<b>High Level Review of the Mt Pleasant Operation Mine Optimisation Modification Environmental Assessment May 2017</b>	
<b>Date:</b>	2 July 2018
<b>To:</b>	The President of the Hunter Thoroughbred Breeders Association
<b>From:</b>	Rod Carr, Director at Marsden Jacob Associates

Marsden Jacob Associates, one of Australia's leading independent economic and financial advisory firms, has undertaken an expert review of the economic analysis of the Mt Pleasant Operation Mine Optimisation Modification Environmental Assessment.

Peter Stephenson, Managing Director of Stephenson Environmental Management Australia (SEMA) (CV attached as Appendix C) was requested by the Hunter Thoroughbred Breeders Association (HTBA) to undertake a review and critique of the air quality matters referred to in the assessment of the proposal conducted by the NSW Department of Planning and Environment in the Independent Planning Commission of New South Wales Proceedings No. D512/18 regarding the Mount Pleasant Operation Coal Mine Extension of Mine Life.

## **Review of the Mt Pleasant Operation MOD3 Mine Optimisation Modification**

FIGURE A-8 NSW OEH MUSWELLBROOK AAQMS PM<sub>10</sub> & PM<sub>2.5</sub> MONTHLY MAXIMA, 2017

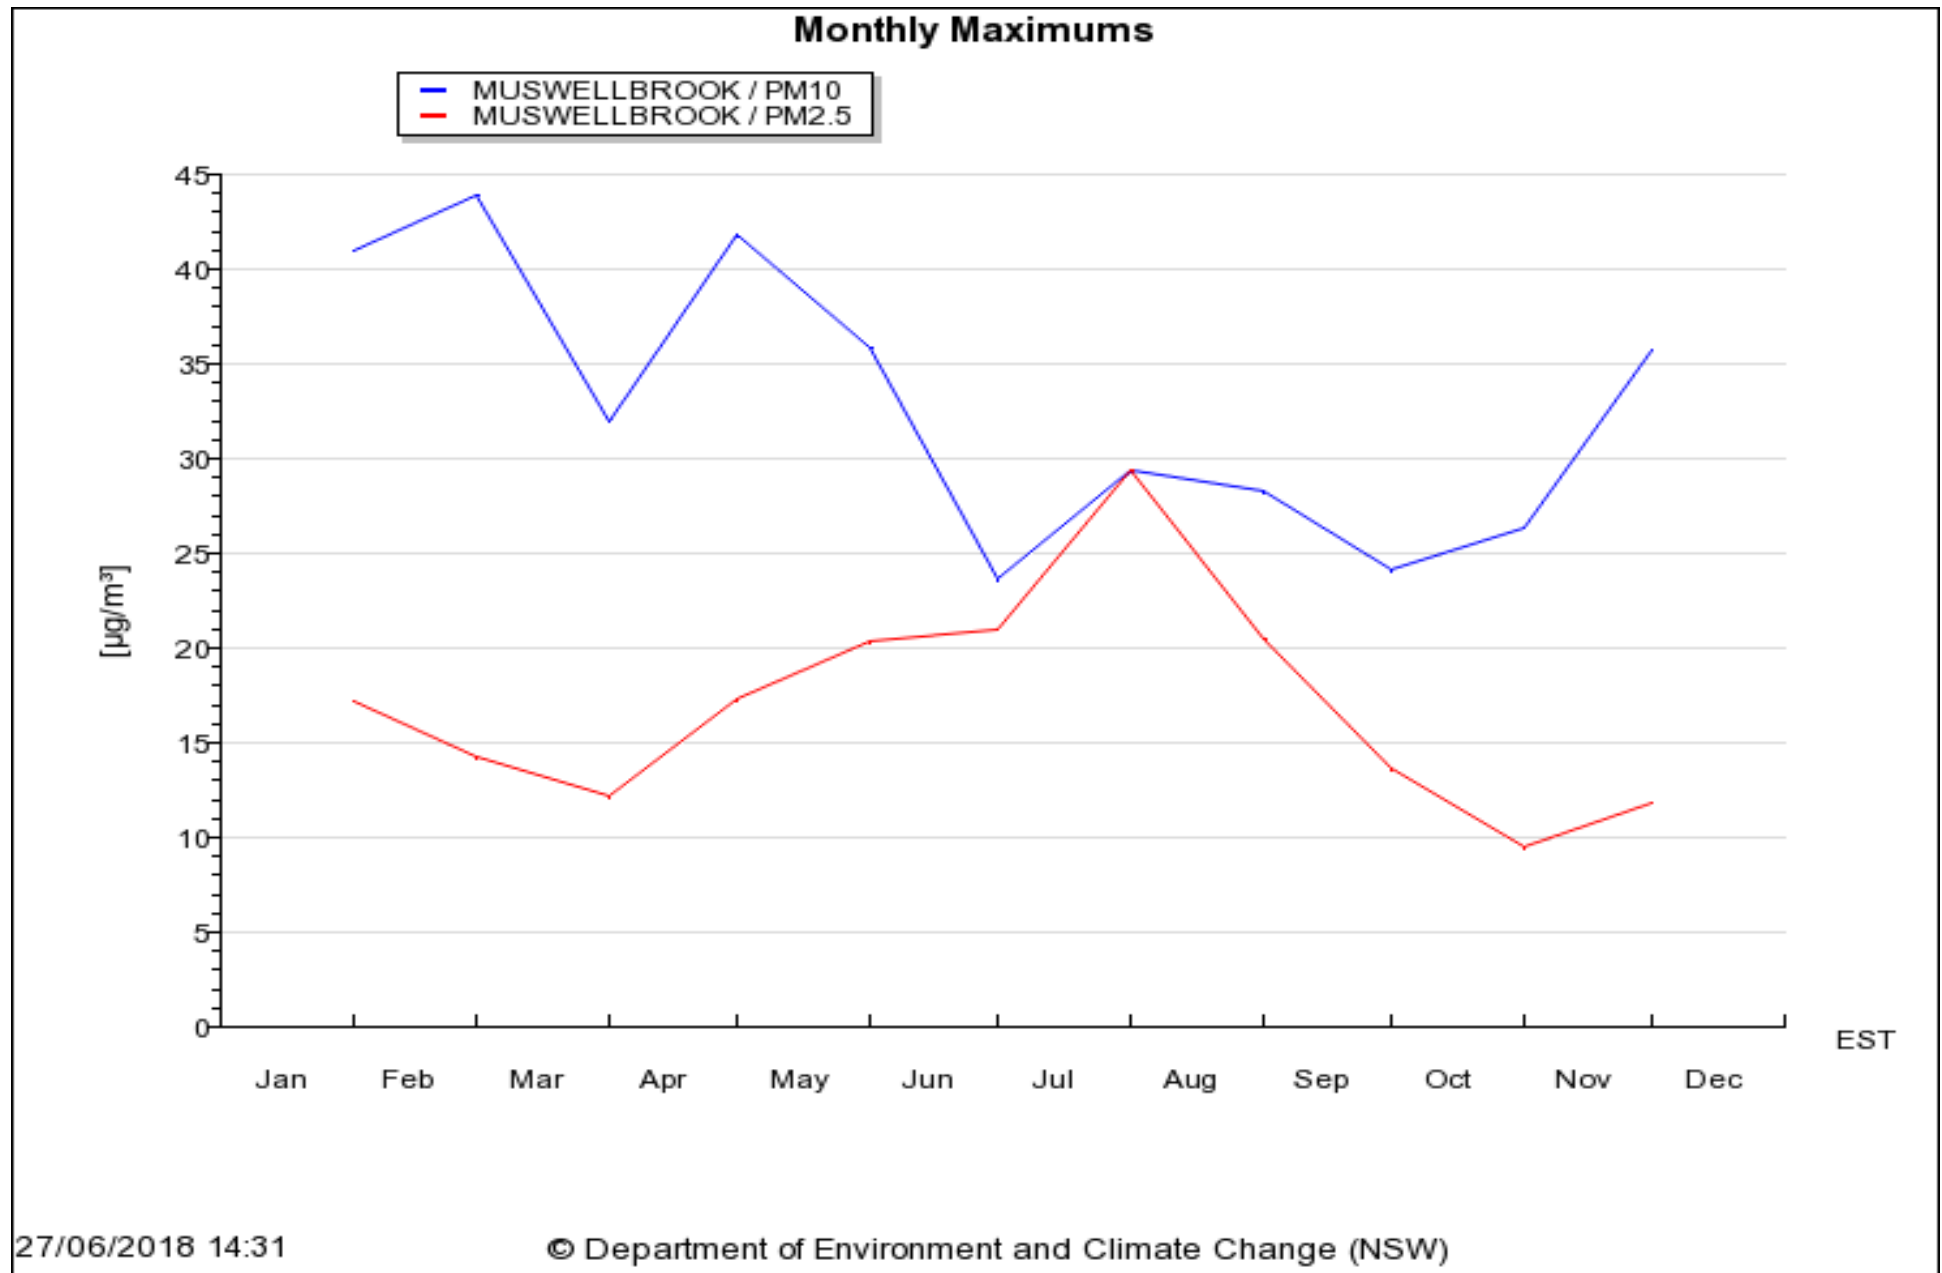
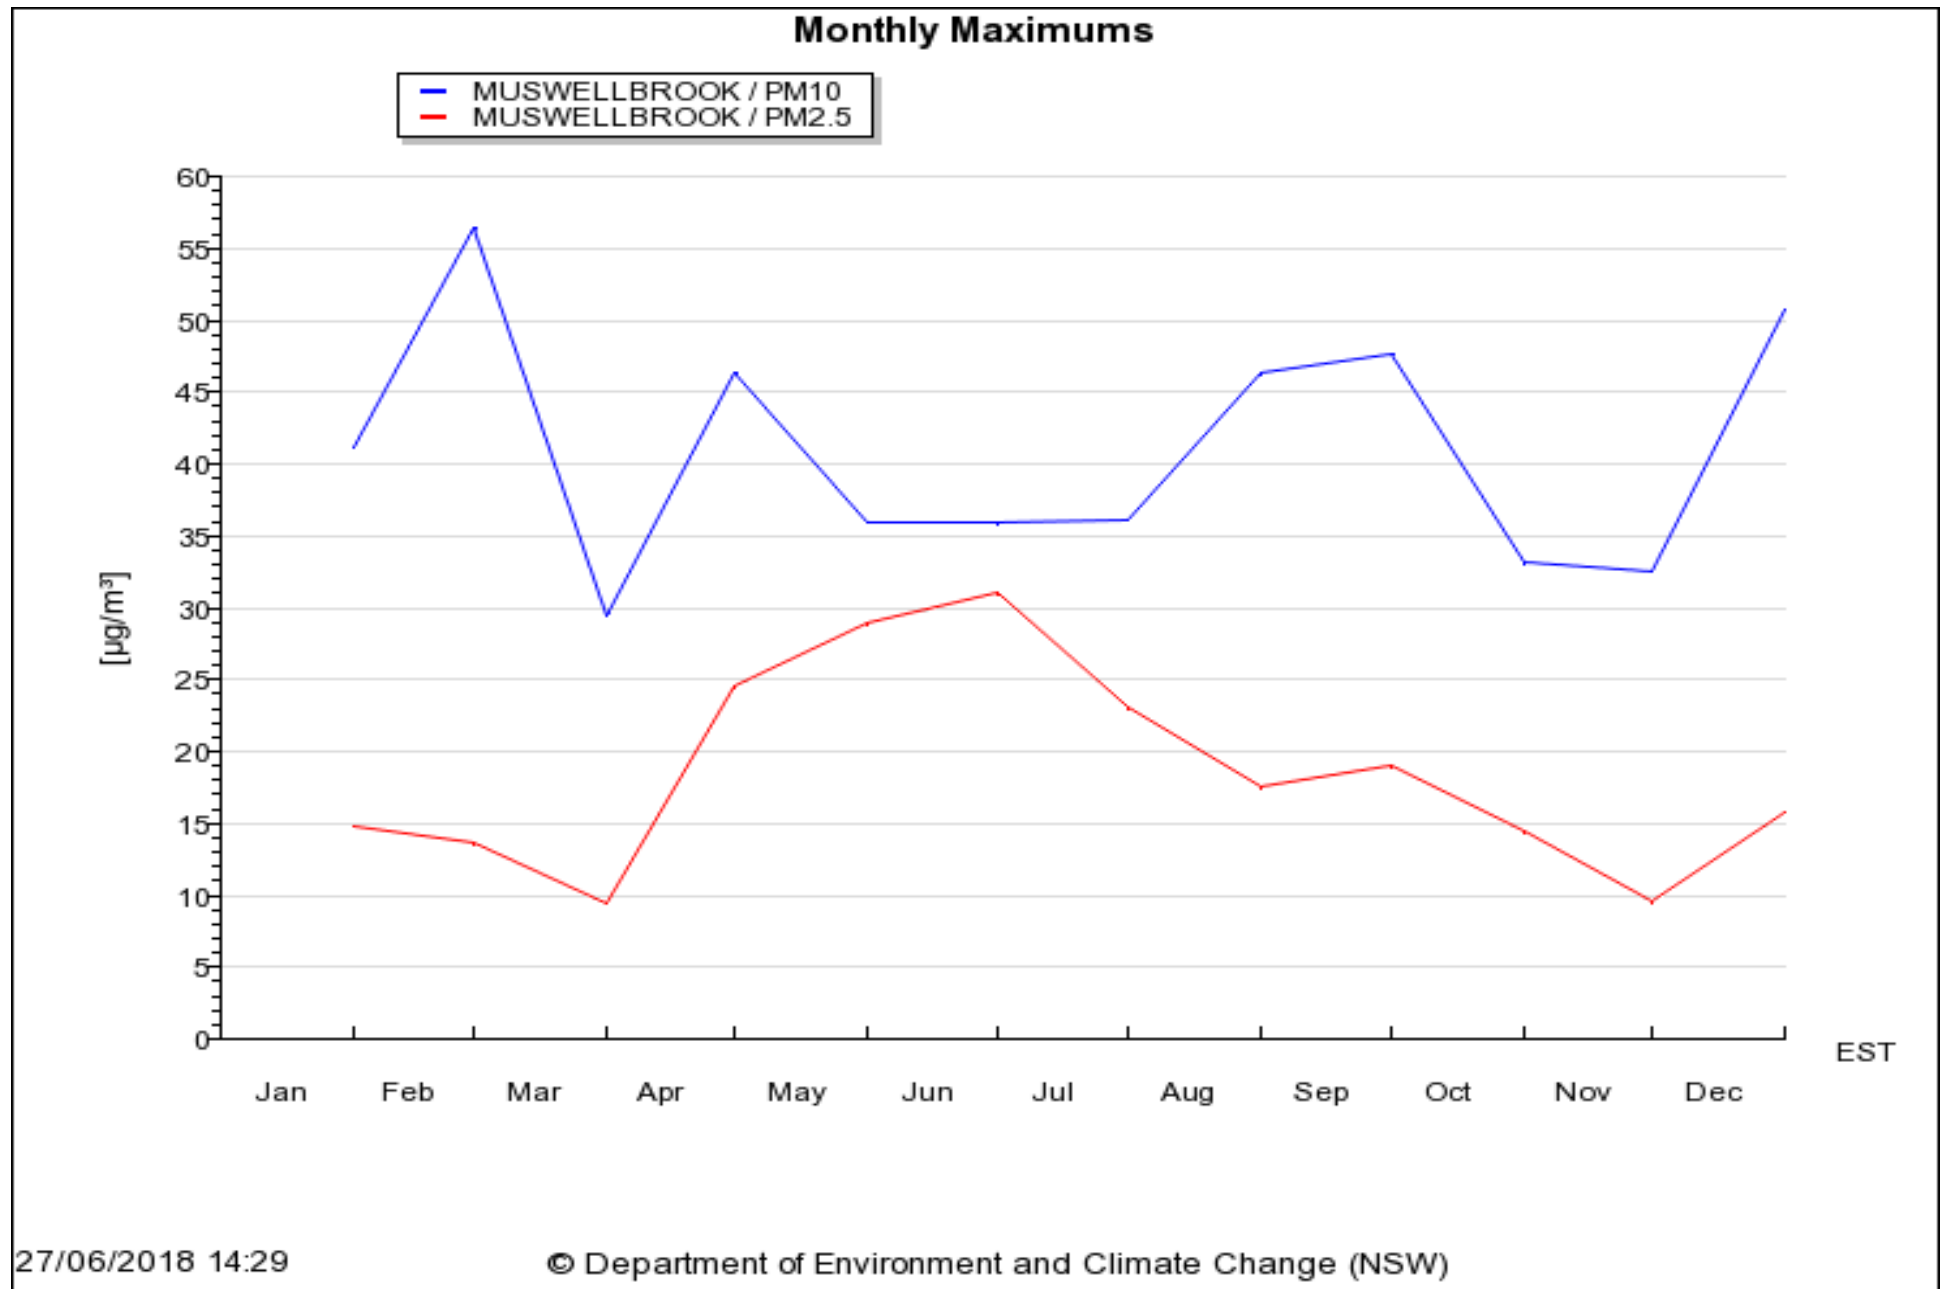
*Furthermore, the plots of data presented in Appendix A of this assessment report show regular exceedances for most of the year. This diminished air quality is the product of previous Planning NSW decisions and further development without radical rework of the mines emission controls will further diminish local air quality.*

**Figure 22**

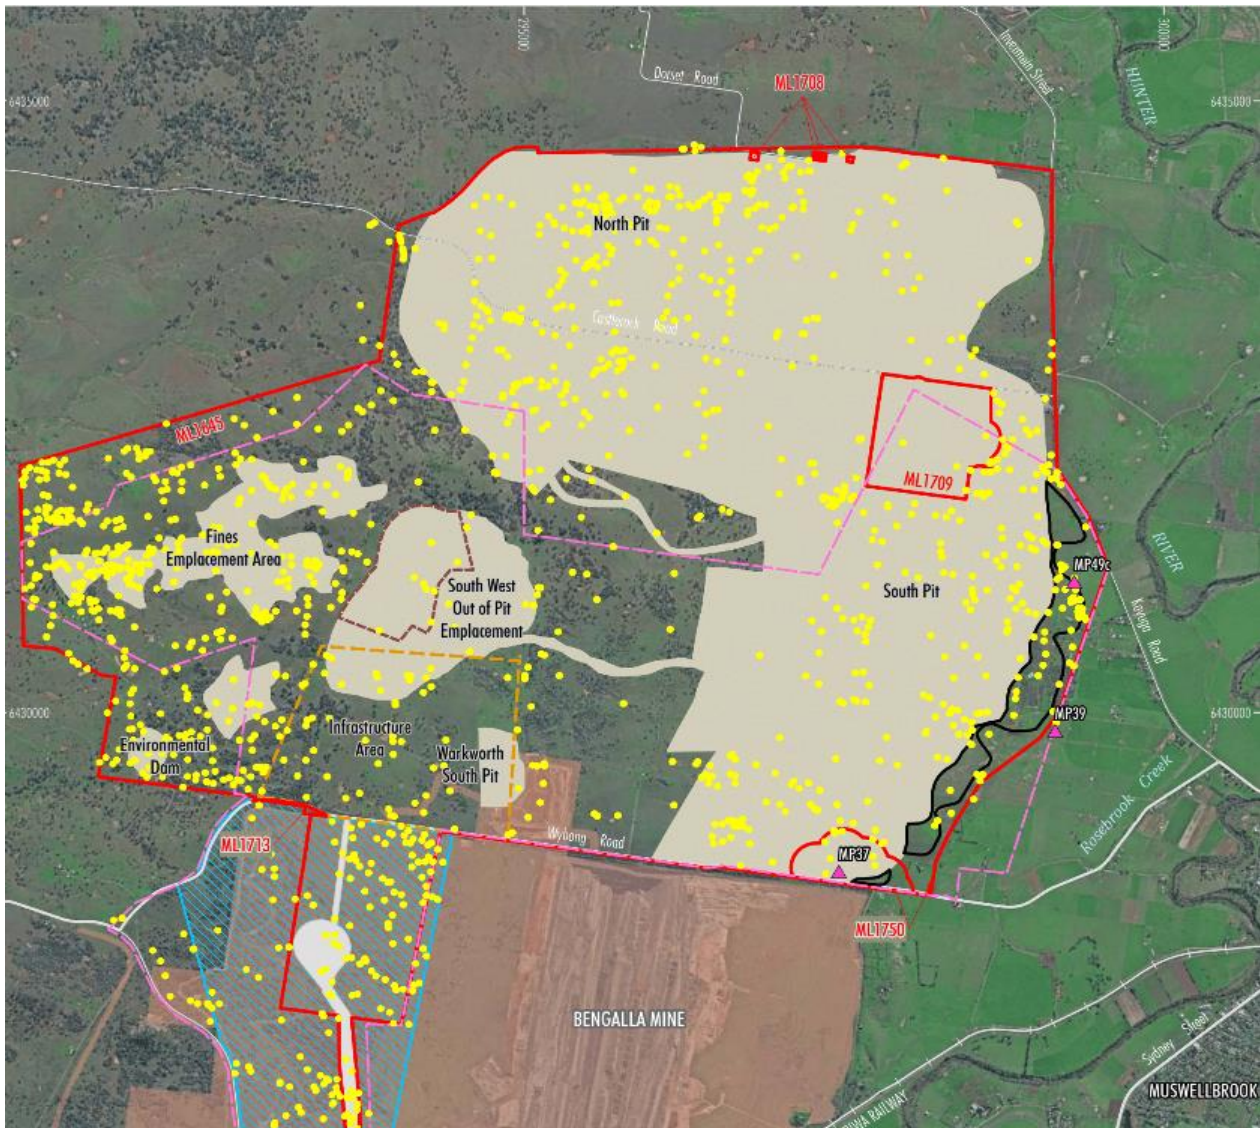
- 74 known Aboriginal sites will be subject to direct impact through this modification (Figure 22, reproduced below);
- citing communicating with the OEH, that existing Aboriginal heritage approvals provide the ability to ‘harm’ these sites;
- the sites do not hold ‘high archaeological’ cultural value, but all Aboriginal heritage material is culturally significant to Aboriginal communities; and

- A additional 74 known Aboriginal sites will be subject to direct impact through this modification.
- This impact is approved by the OEH under AHIP #C0002053, with management delivered under the Aboriginal Cultural Heritage Management Plan.
- In the Secretary’s Environmental Assessment of Aboriginal Heritage pre-existing assessments and technical reports prepared by the proponent and its consultants have relied upon in considering the proposed modification.

- The impacts on the Aboriginal cultural landscape and cumulative impact to Aboriginal heritage across the region has not been considered in the assessment of this Modification. Aboriginal heritage considered only tangible sites.

Figure 22

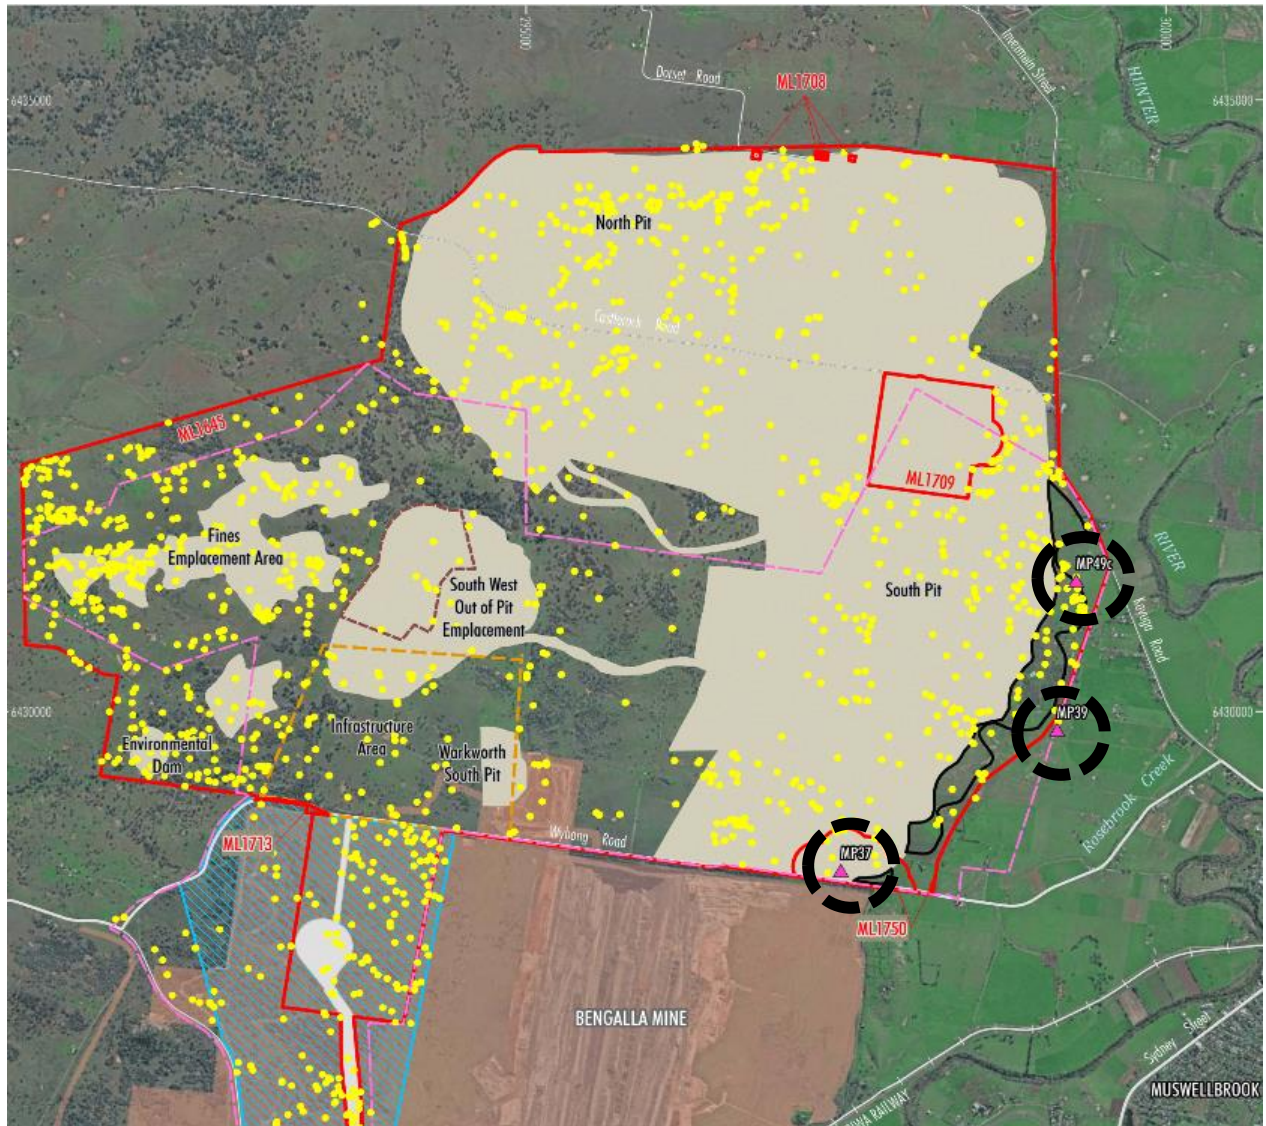
- MP49c former (potential) dairy site with some scattered surface remains;
- MP39; 'Rosebrook Quarry, a former sandstone quarry. Is assessed as having High local heritage significance as it illustrates technical achievement in the quarrying of building stone and includes evidence of a process that has since been discontinued; and
- MP37 'Berrywood Homestead' a 20<sup>th</sup> century homestead with outbuildings). Assessed as being High local significance as it is associated with a significant activity and historical phase.

The Environmental Assessment states that MP49c is approximately 10 metres away from the Emplacement Extension. Both MP37 Berrywood Homestead and MP49c, the former potential dairy will be disturbed by the approved open cut mining activity and associated infrastructure. MP39, the former quarry may be subjected to indirect impacts due to mining activity. Management of the heritage sites will be subject to the measures and requirements in the historic heritage management strategy.

- MP39, the former quarry may be subject to indirect impacts due to mining activity.
- In the Secretary's Environmental Assessment of Historic Heritage pre-existing assessments and technical reports prepared by the proponent and its consultants have been relied upon in considering the Modification 3.

## 2021 annual production volume achievable vs MOD3 EA production schedule for waste rock

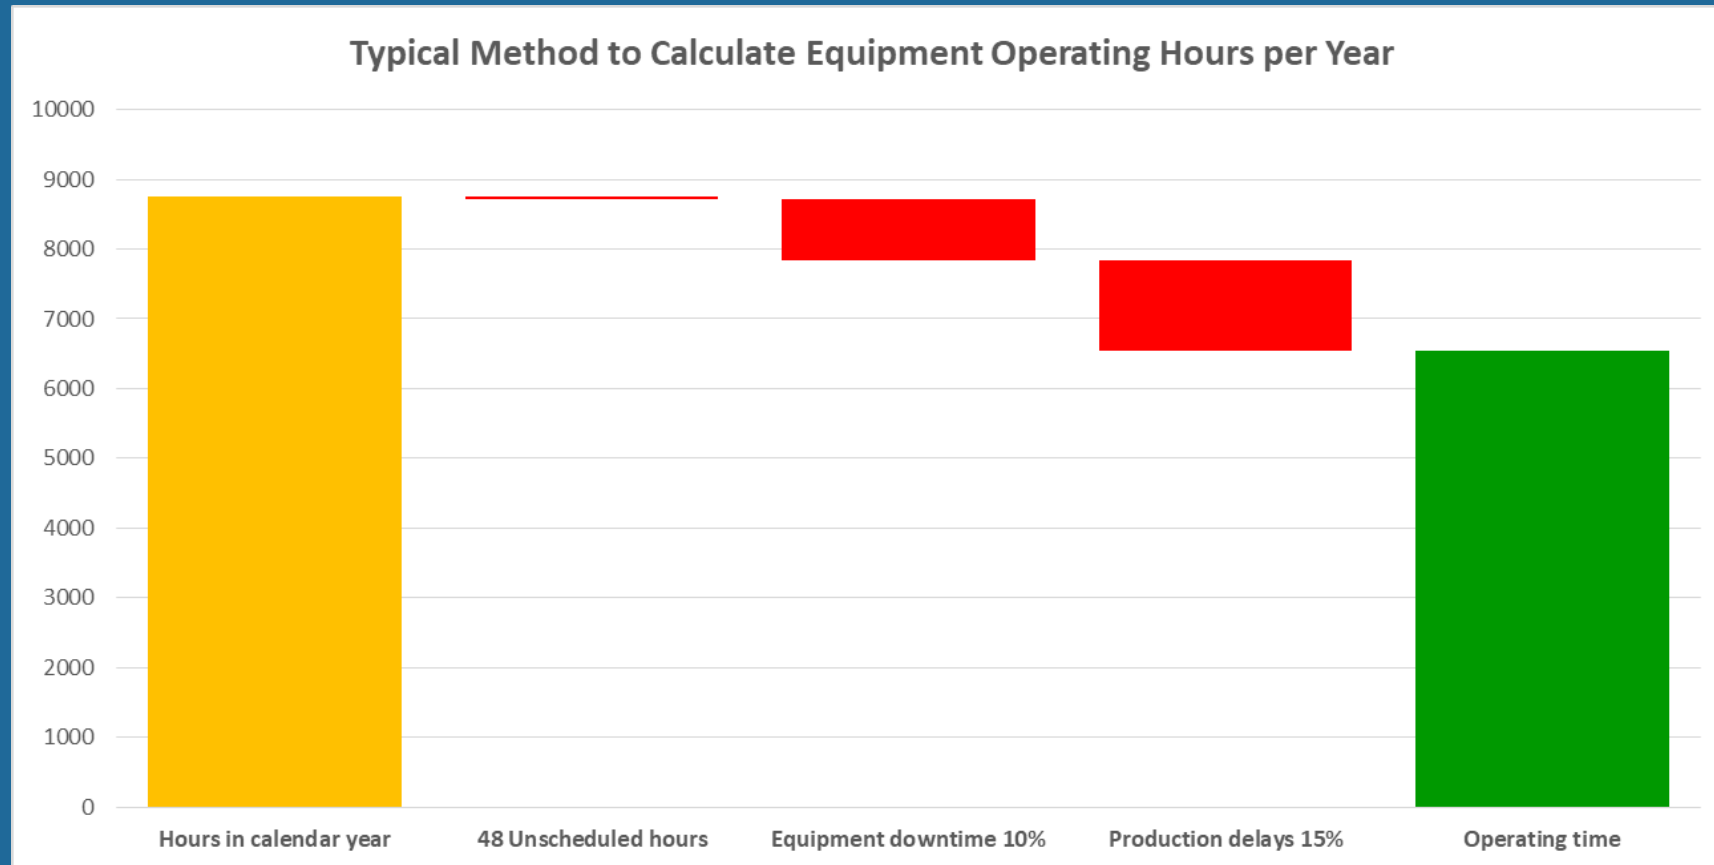
MACH MOD3 Waste rock schedule Volume for 2021	Likely output range for each 996 excavator	Likely output for 996 fleet (2)	Likely output for Ex 3600 excavator	Likely total waste output achievable for total excavator fleet	Estimated waste volume shortfall in 2021
31.28 million bcms	8-10 million bcms	16-20 million bcms	4-5 million bcms	20-25 million bcms	<b>6-11 million bcms</b>

**The 2021 shortfall of 6-11 million bcms of waste rock movement has to be recovered by using additional equipment**

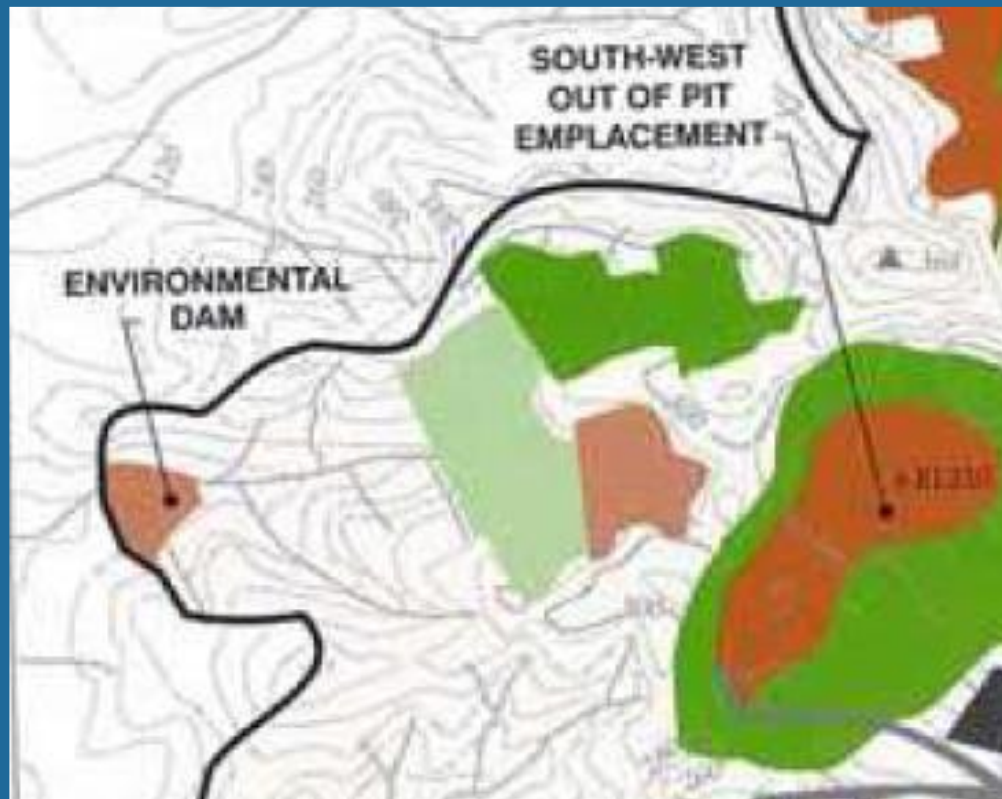
**When additional excavators are used to make up the quantity shortfall additional trucks and additional dozer and watercart operating hours will also be required.**

**This additional equipment operating creates additional dust and additional noise. These additional impacts have not been modelled or assessed.**
